March 21, 2010

In regards to OMB case # PL091182 regarding the West Side Lands in the City of Waterloo

Figure 1: Estimated Area Contributing to ESPA 19

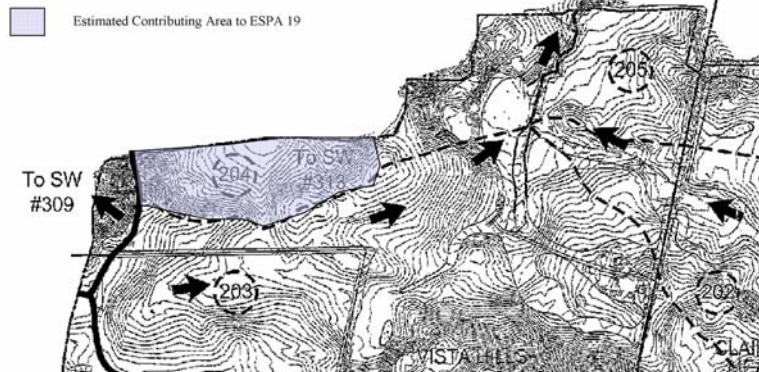
Here is the delineation of the capture zone as created by my senior hydrologist, Stan Denhoed, in his affidavit used at the experts' meeting for the previous OMB appeal PL071044.

With over a year since the OMB ruling for PL071044, the current draft plan for Vista Hills remains unchanged. The draft plans being used for OMB hearing PL091182 still reflect a situation of adverse environmental impact as defined in the Regional Official Planning Policies Plan, and as prohibited by policy 4.3.15.

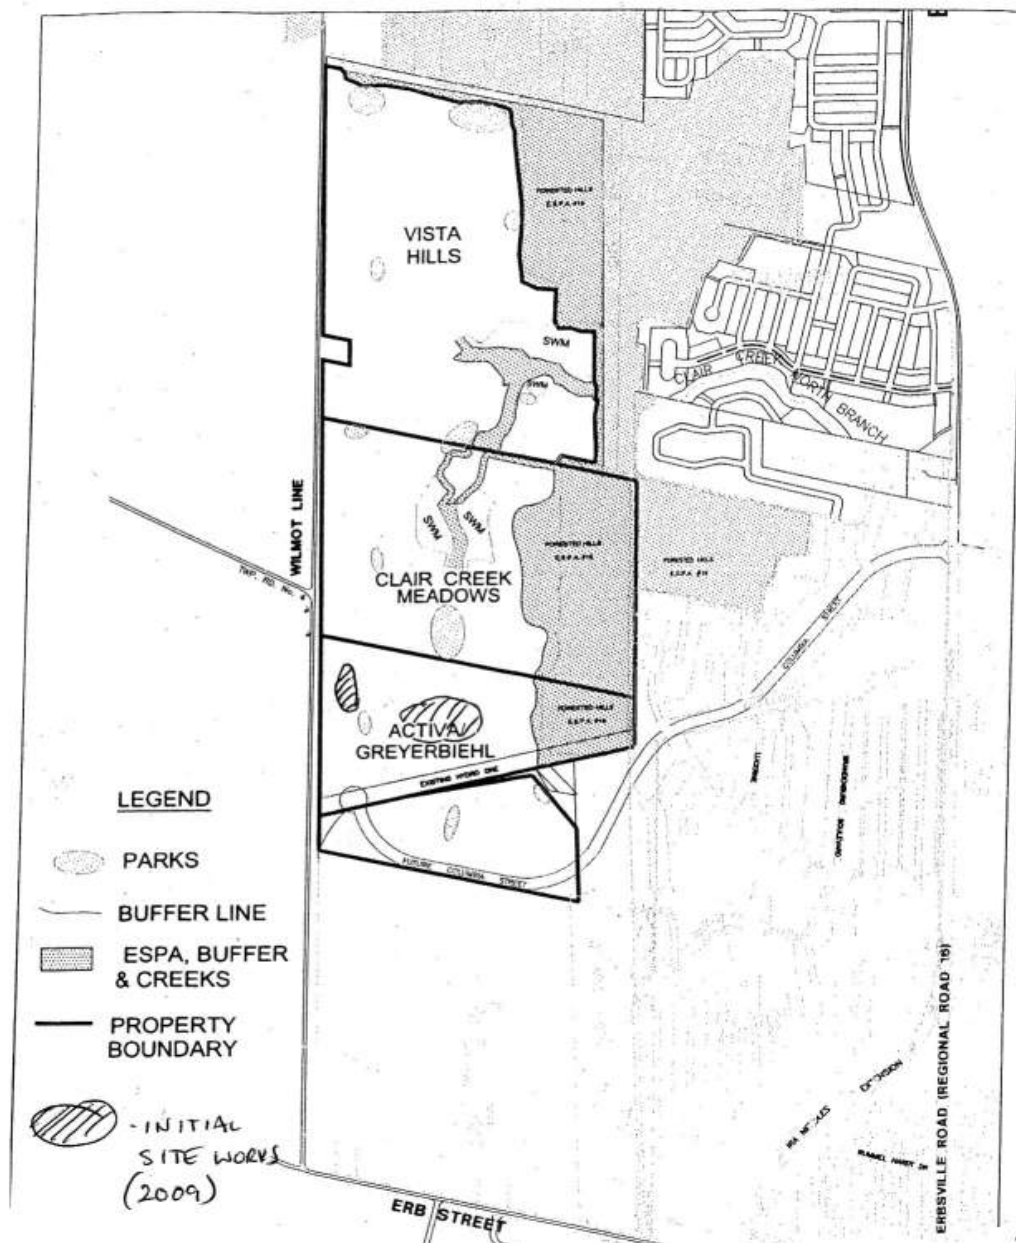
The map shows the delineation of the proposed augmentation area as well as a Storm Water Management Pond (SWM) is to be installed to the north on top of reaches of Clair Creek; in spite of the fact that the OMB process PL071044 secured those SWM ponds would be **offline**. This measure was required to protect the fisheries in Clair Creek as noted in the experts' minutes. Exhibit 8 section regarding Fish section 2.

LOCATION MAP

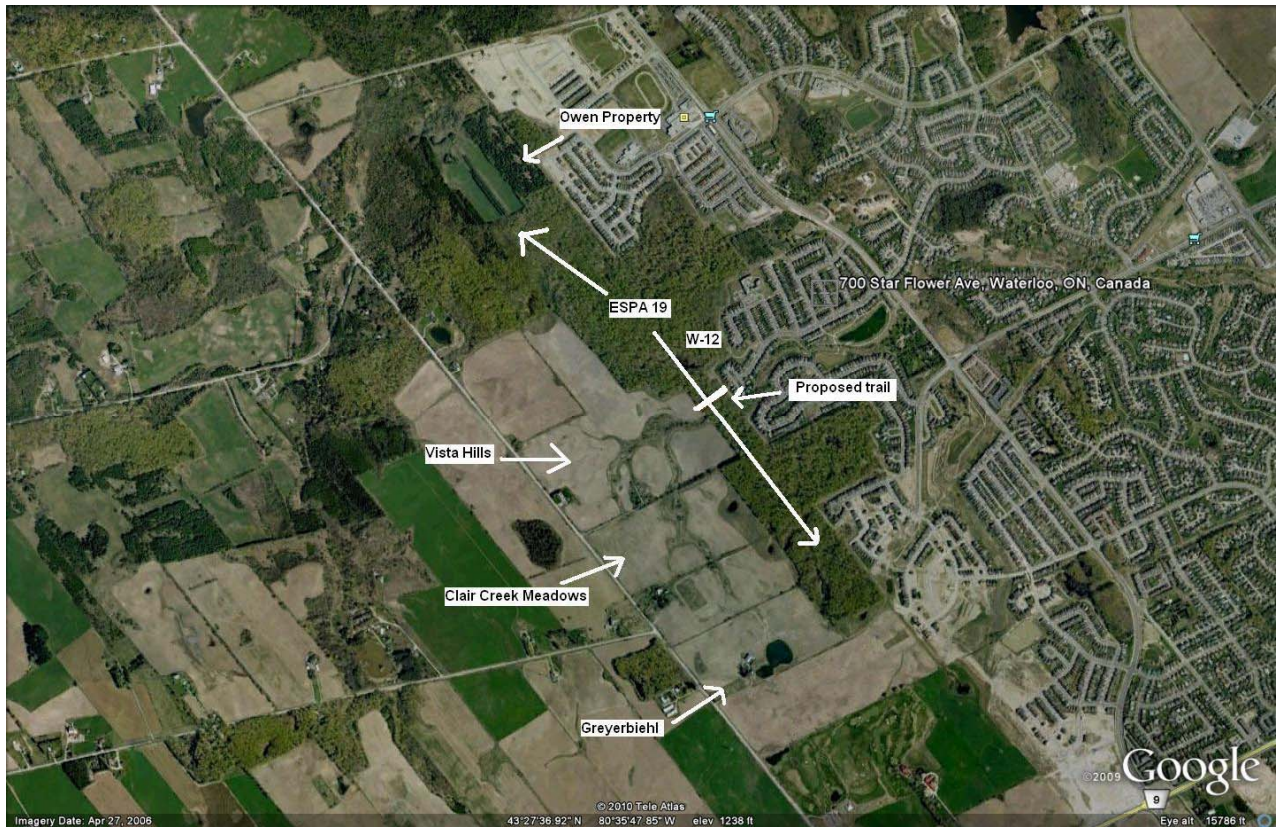
The servicing for the West Side Lands subdivision is planned to be built with servicing underground and an asphalt trail over top through areas of ESPA 19 between the Columbia Forest Subdivision and Vista Hills. The trail is going to feature lighting as well.

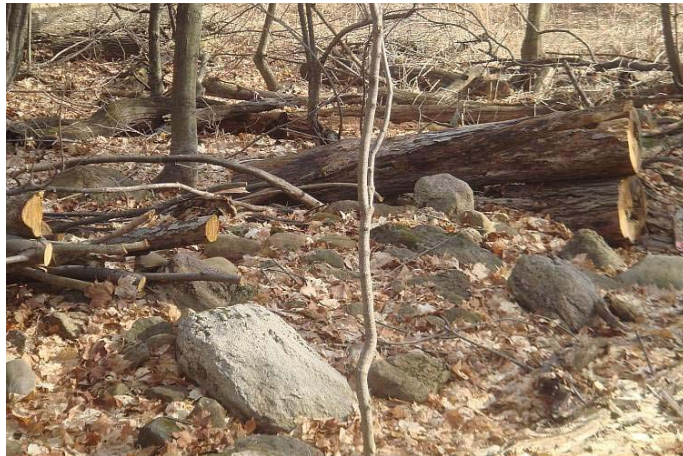
The City of Waterloo sign confirms plans to create a corridor 4-10 meters wide. Below is a photo of testing taking place adjacent to a vernal pond. Trees were removed in the capture zone in areas that slope down from the buffer zone along Vista Hills.

I have witnessed the removal of trees to facilitate hydrological testing in ESPA 19 without regard to the fact that the tree removal will adversely impact the existing hydrology. Removing heritage trees and replacing them with saplings will not reasonably maintain the same hydrologic regime or replace the function of mature trees in this forested primary recharge area.
